NINE MILE POINT NUCLEAR STATION, UNIT NO. 1

AMENDMENT TO FACILITY OPERATING LICENSE

Amendment No. 41
License No. DPR-63

SUPPORTING AMENDMENT NO. 41 TO FACILITY OPERATING LICENSE NO. DPR-63

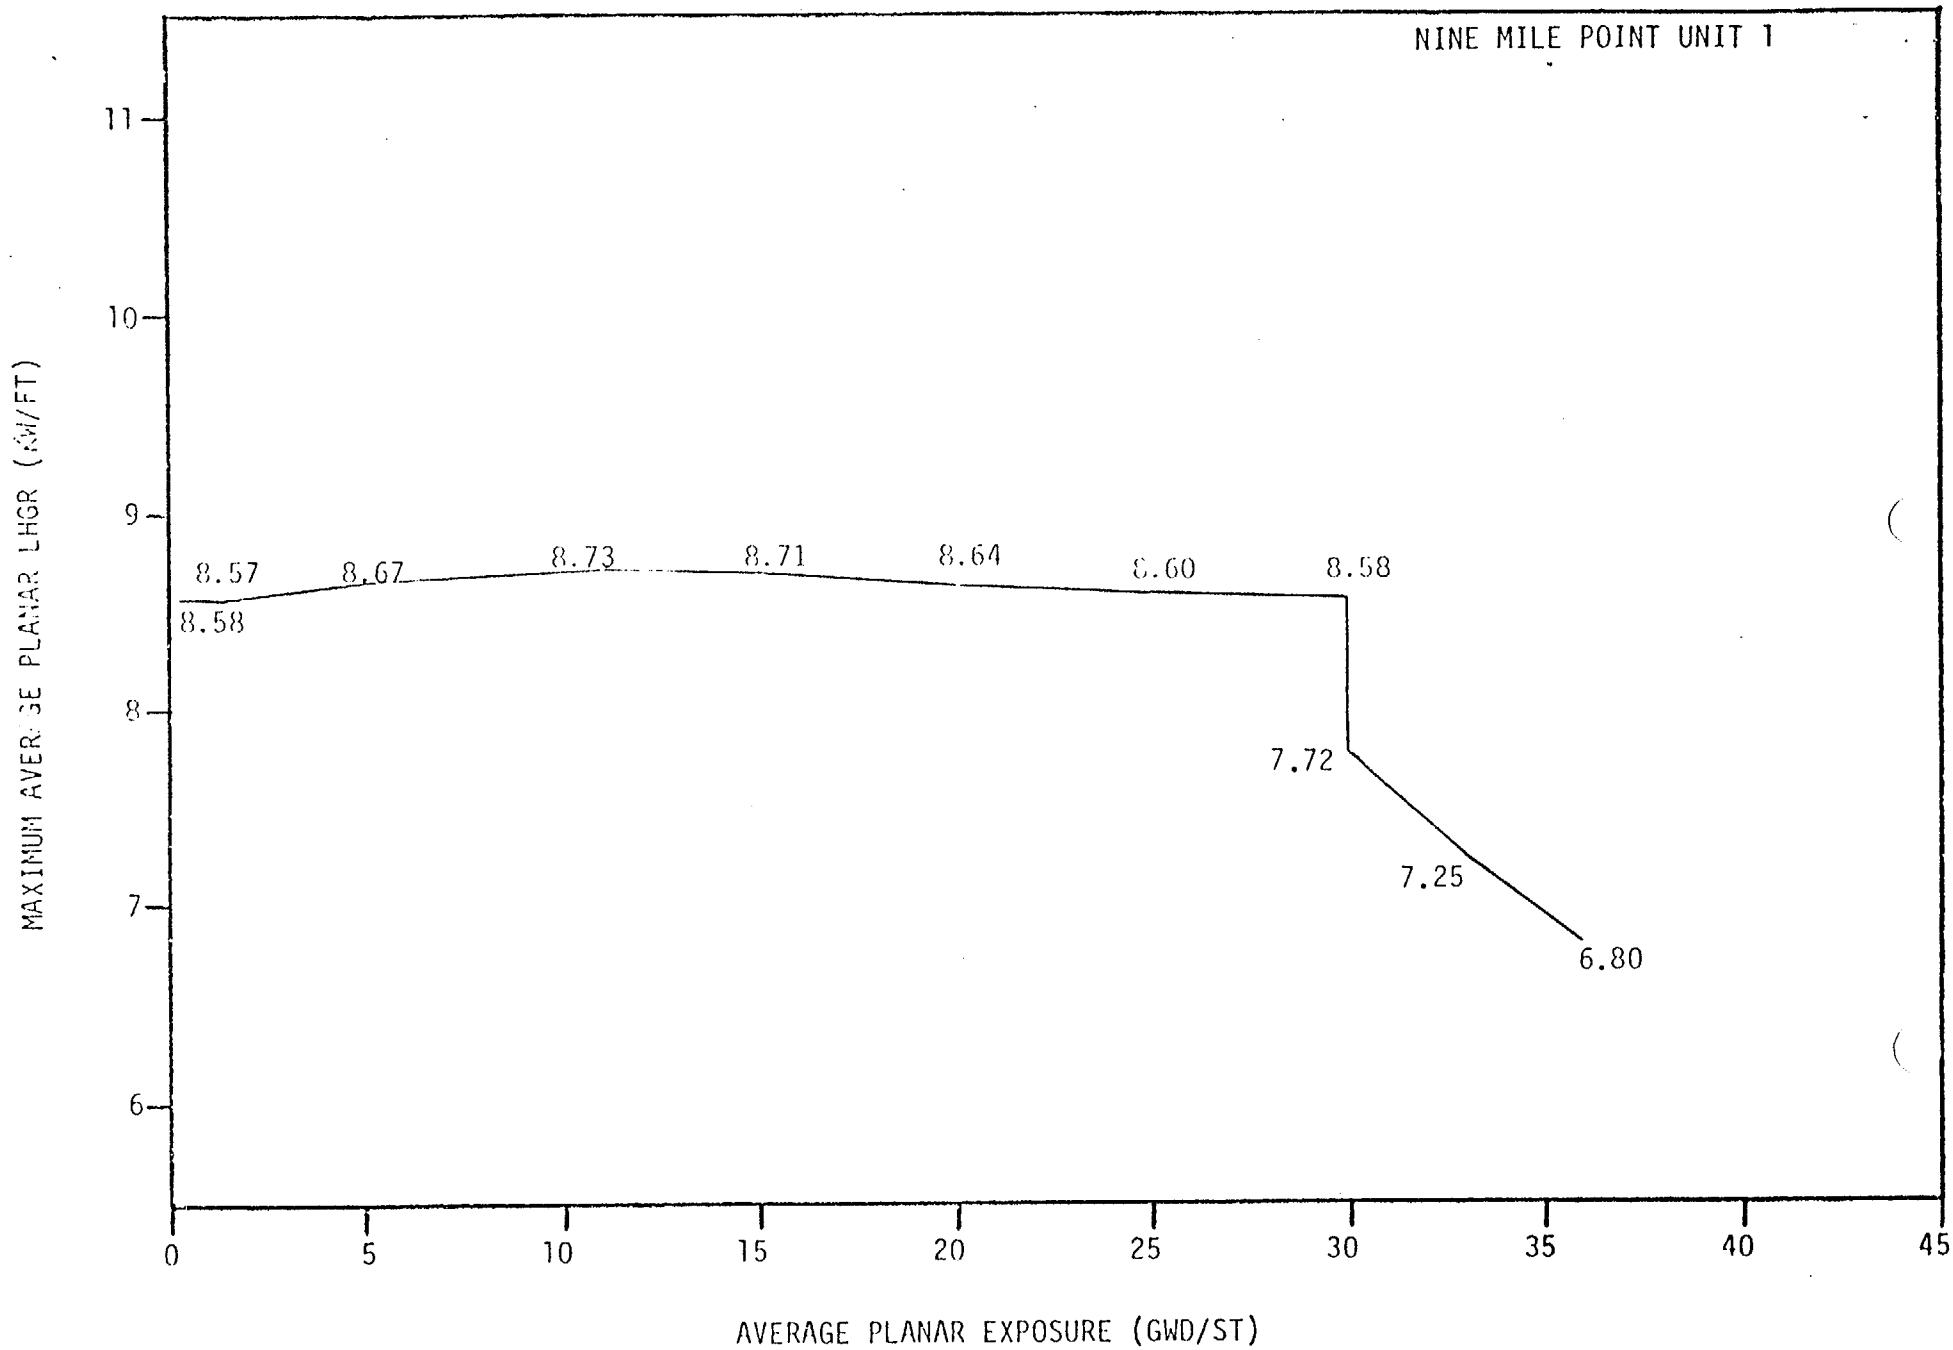
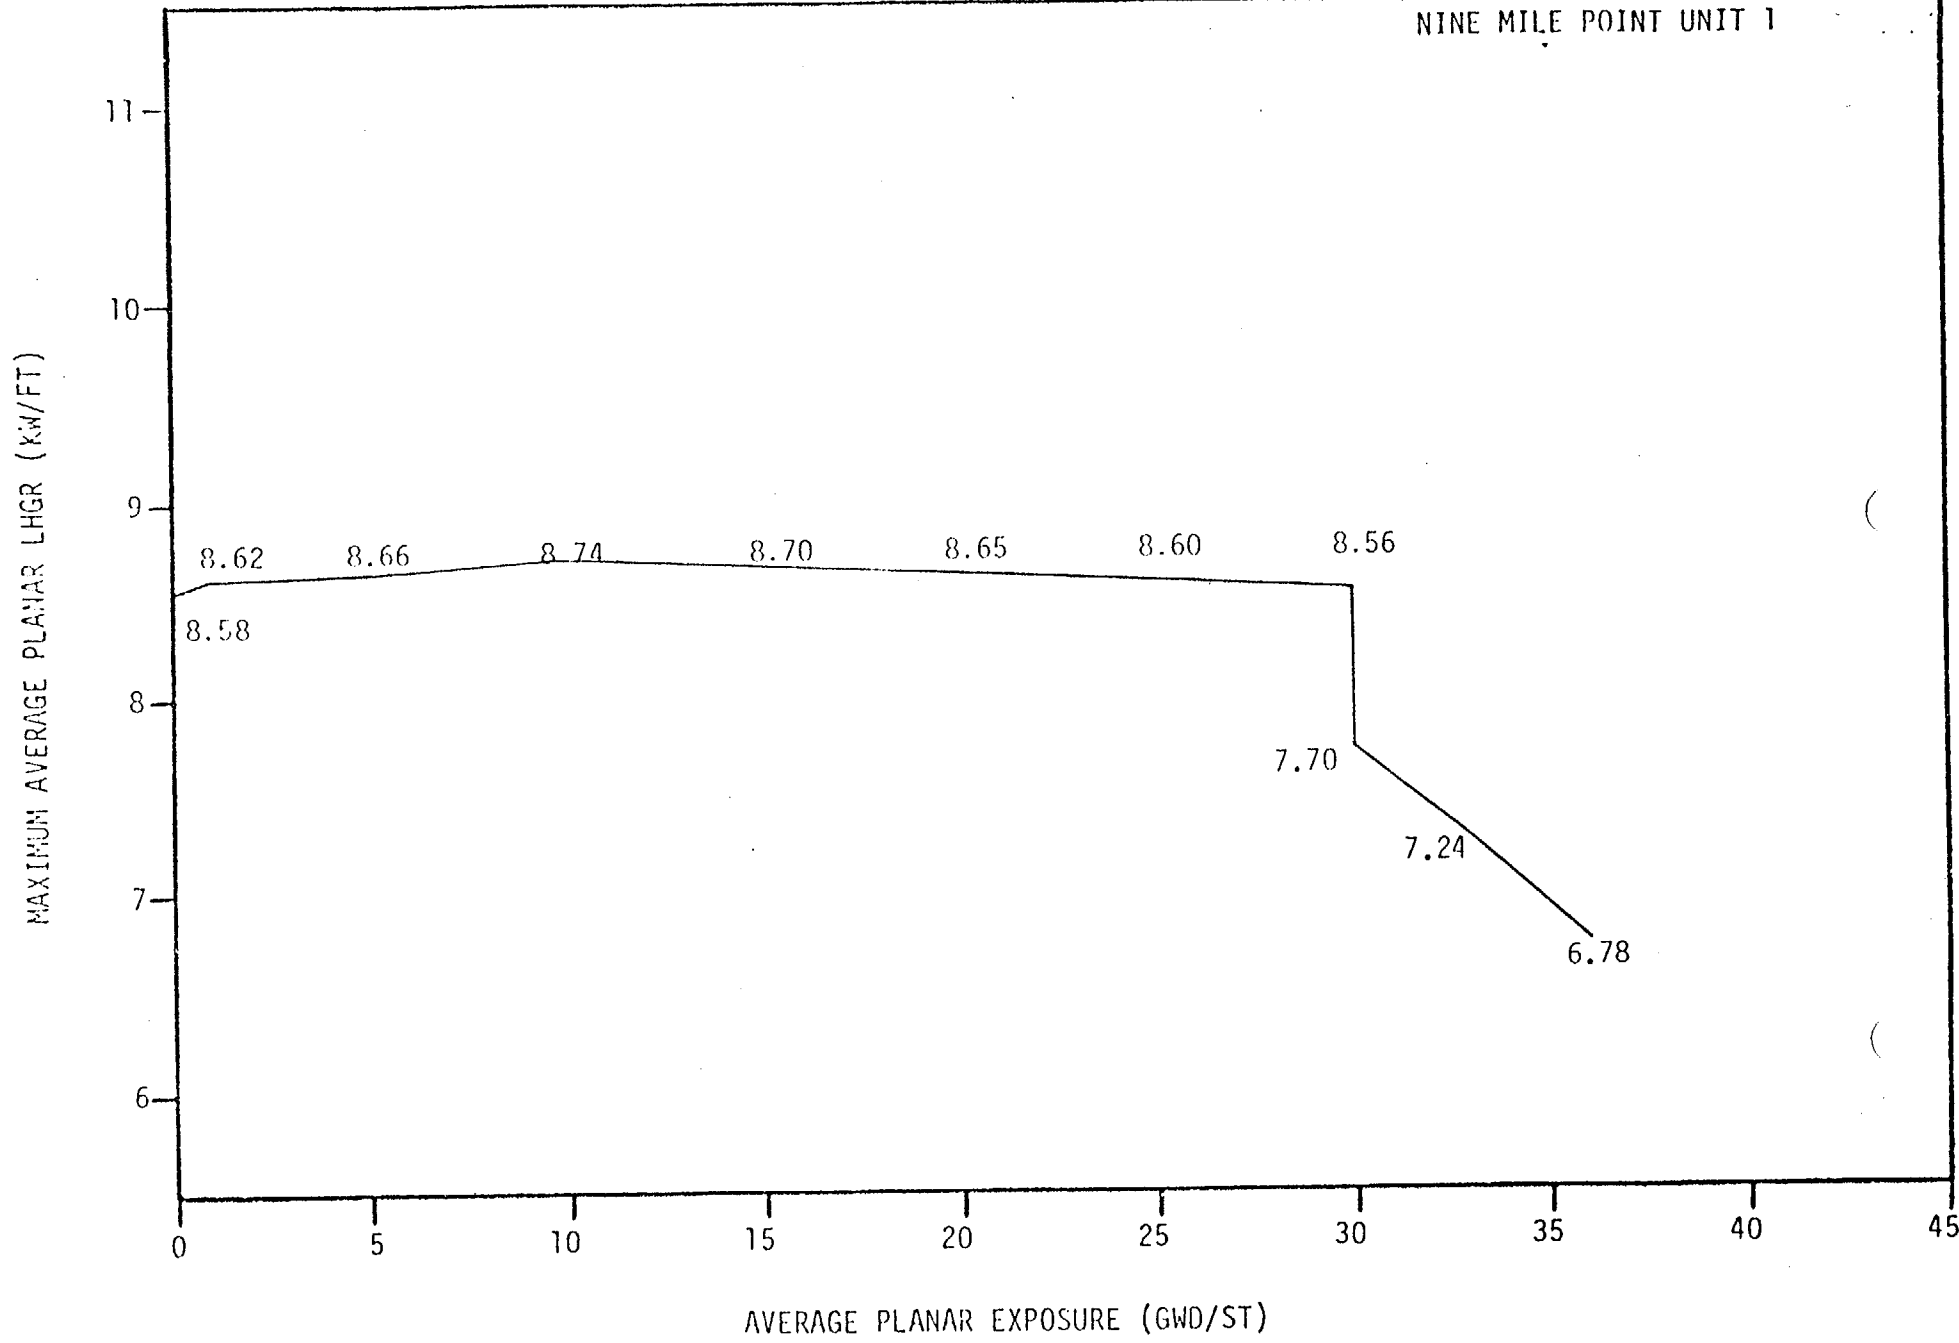
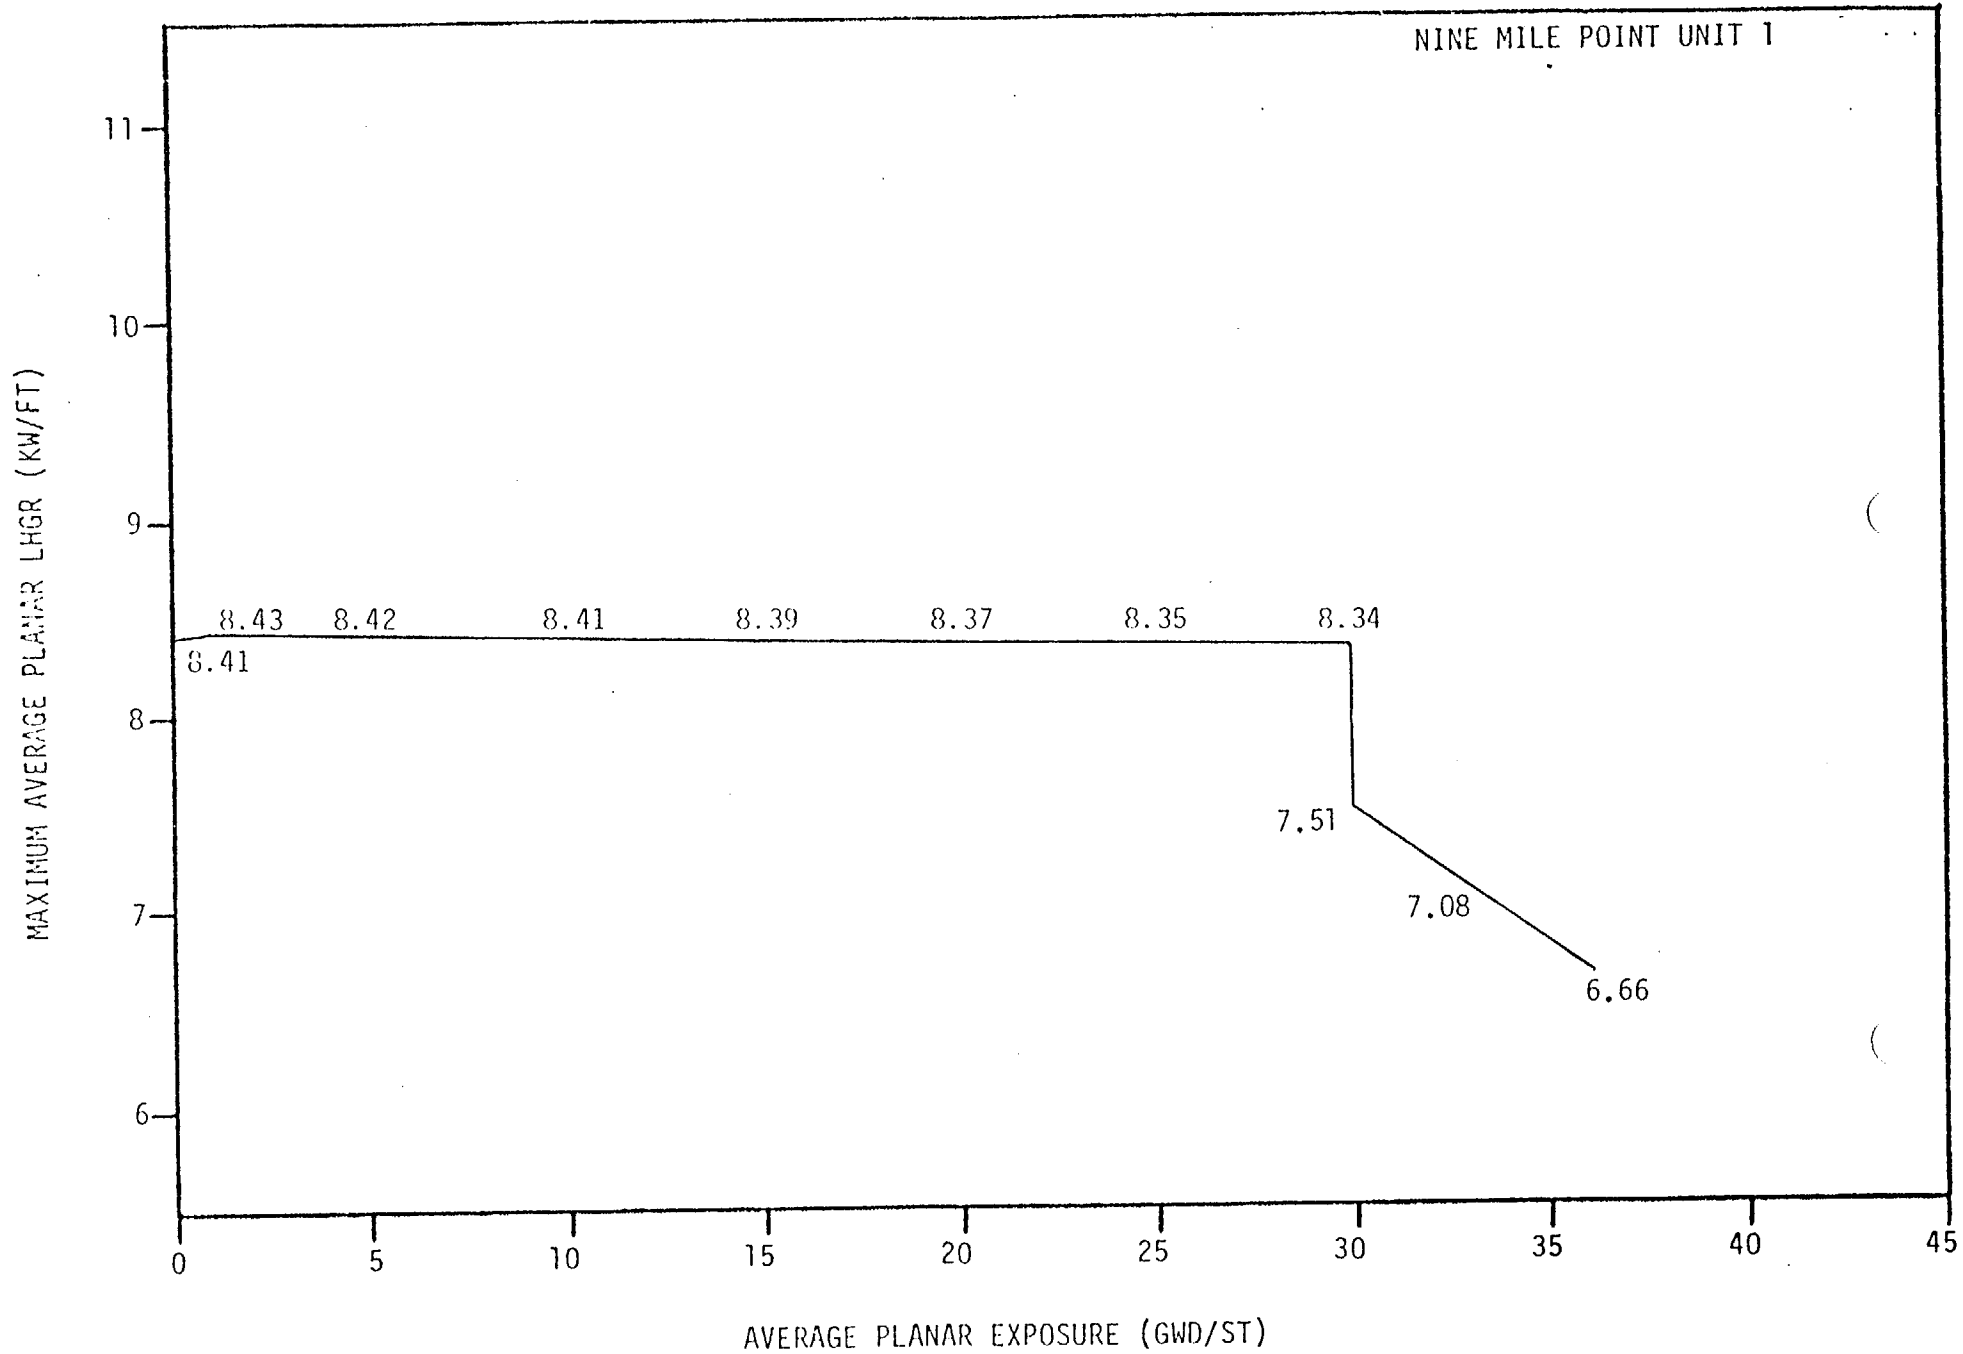
The proposed new MAPLHGR limits are calculated out to higher exposures (from 30,000 MWD/STU to 40,000 MWD/STU) by the previously approved methods initially used for the fuel with exposures up to 30,000 MWD/STU. The changes in the four figures (Figures 3.17 a, b, c, and d) are the result of extending the MAPLHGR limits to 36,000 MWD/STU for 8DB250 fuel, 8DB274L and 9DB274H fuel, 8DNB277 fuel and P8NDB277 fuel, respectively.

Although the methodology used is generally applicable for an average planar exposure up to 36,000 Mwd/t, the staff believes the effects of enhanced fission gas release in high burnup fuel (above 30,000 Mwd/t) are not adequately accounted for in your submittals. To compensate for this deficiency, the staff has estimated the amount of MAPLHGR limits in Figures 3.1.7a to 3.1.7d of the proposed Technical Specifications should be reduced to assure the peak cladding temperature and local oxidation are below the limits allowed by 10 CFR 50.46. The reduction imposed is based on the results of comparative calculations of fuel volume average temperature performed by General Electric using GEGAP III with and without an NRC correction for enhanced fission gas release and the relationship between peak cladding temperature and MAPLHGR increased presented in NEDE-23786-1-P. In estimating the MAPLHGR reduction, the staff conservatively assumed the change in volume average temperature can be translated directly into a peak cladding temperature change. Table 1 gives the percent reduction in MAPLHGR as a function exposure above 30,000 Mwd/t for the types 8DB250, 8DN274L, H, 8DNB277 and P8DNB277 fuel in your submittals. We have limited the extension of the MAPLHGR to 36,000 Mwd/t to account for the uncertainties in enhanced fission gas release above this exposure.

These MAPLHGR reductions to the licensee's proposed Technical Specifications in Figures 3.1.7a to 3.1.7d assures that the cladding temperature and local cladding oxidation would remain below the 2200°F (peak cladding temperature) and 17 percent (local cladding oxidation) limit allowed by 10 CFR 50.46 when the effects of enhanced fission gas release above 30,000 Mwd/t are conservatively accounted for.

TABLE 1 - REDUCTION IN MAPLHGR AS A FUNCTION OF EXPOSURE

Exposure Mwd/t	30,000	32,000	34,000	36,000
Reduction MAPLHGR, %	10.0	13.33	16.67	20.0
